AMENDED ARRANGEMENT OF DECK PLATING

PLAN NO 32.
DRAWN BY J.W.T.
CHECKED BY

W. GRAY & CO. LIMITED
21. 3. 28
WEST HARTLEPOOL

8 City of Dieppe
W. H. Pl. rep. 16775

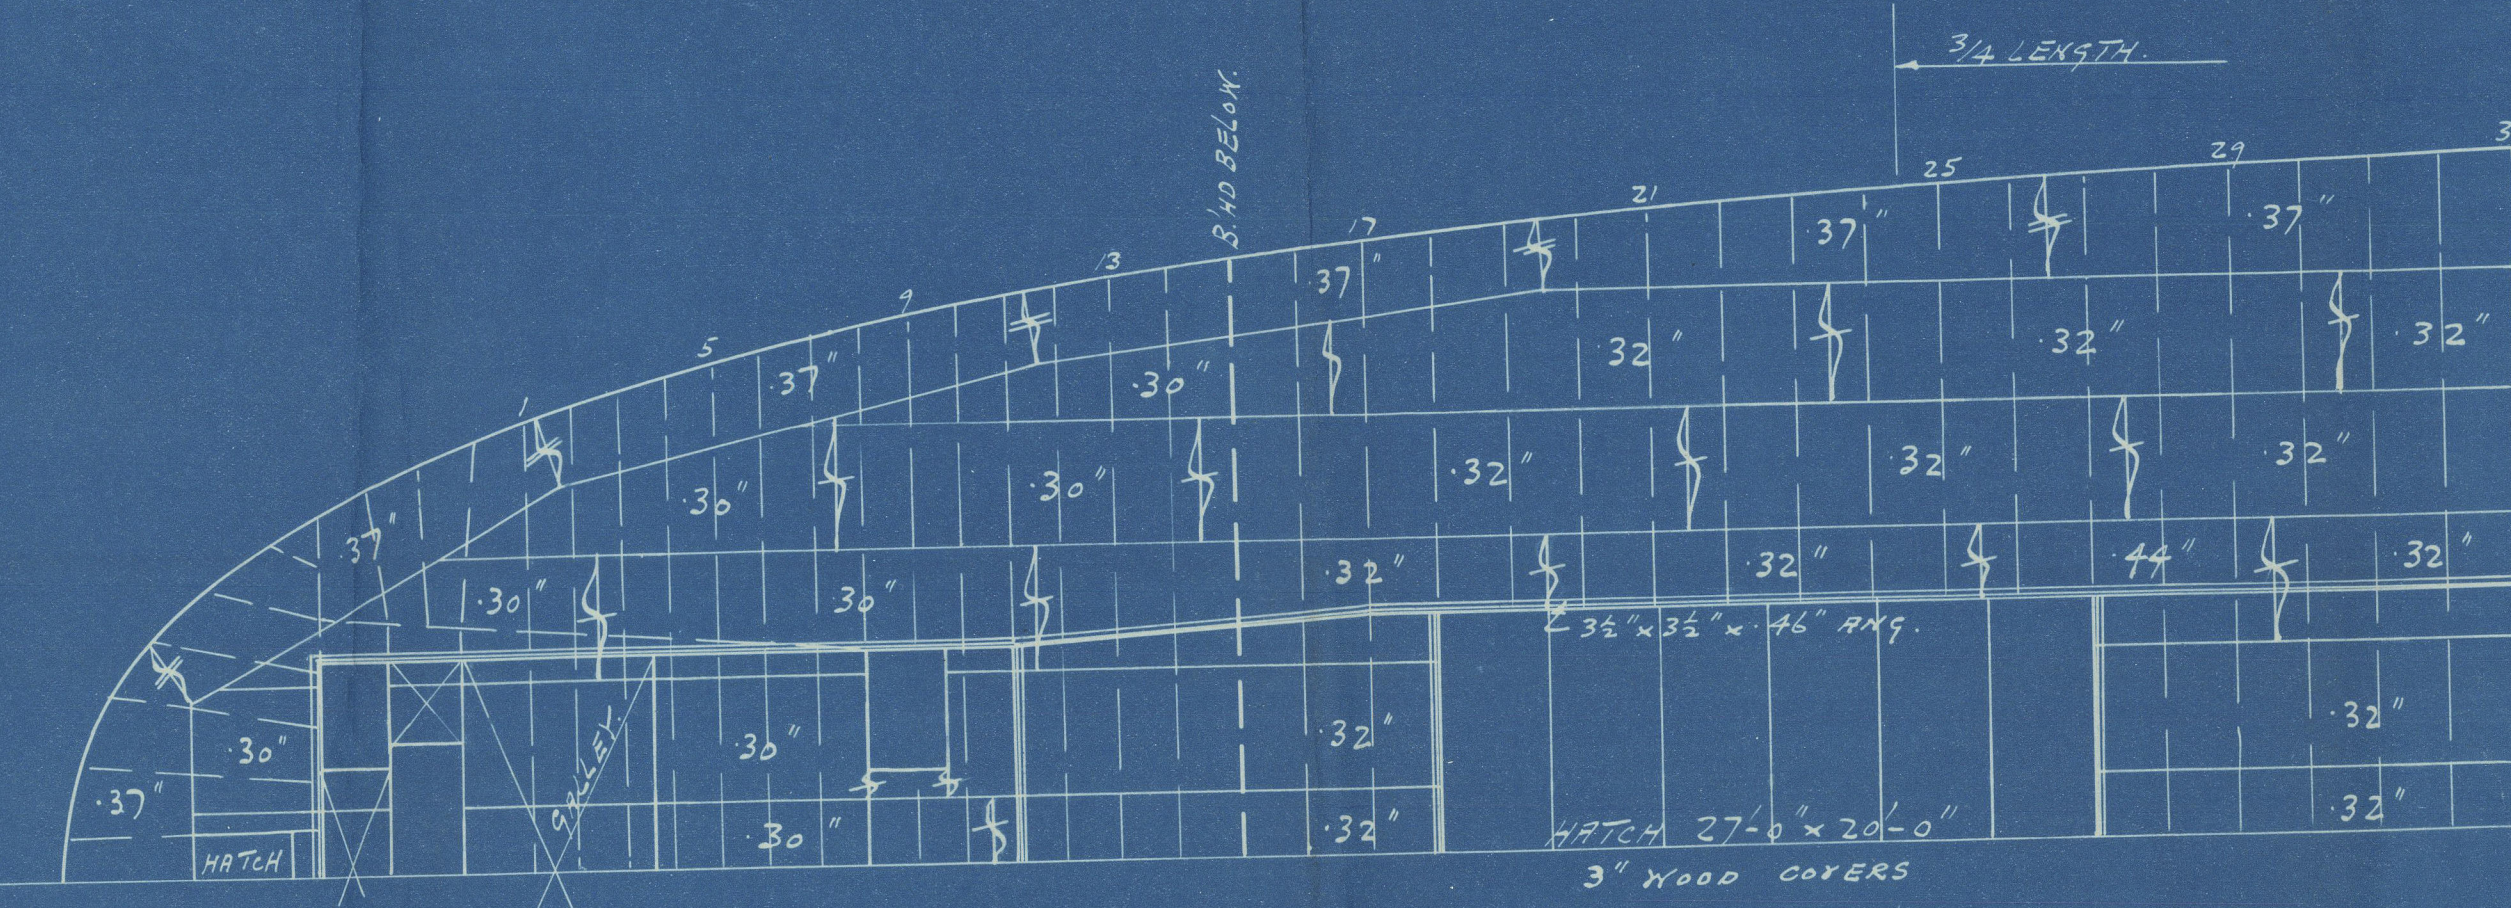
NOTE - DECK PLATING INCREASED AT HATCH CORNERS & CORNERS OF LARGE DECK OPENINGS IN LIEU OF FITTING DOUBLINGS.
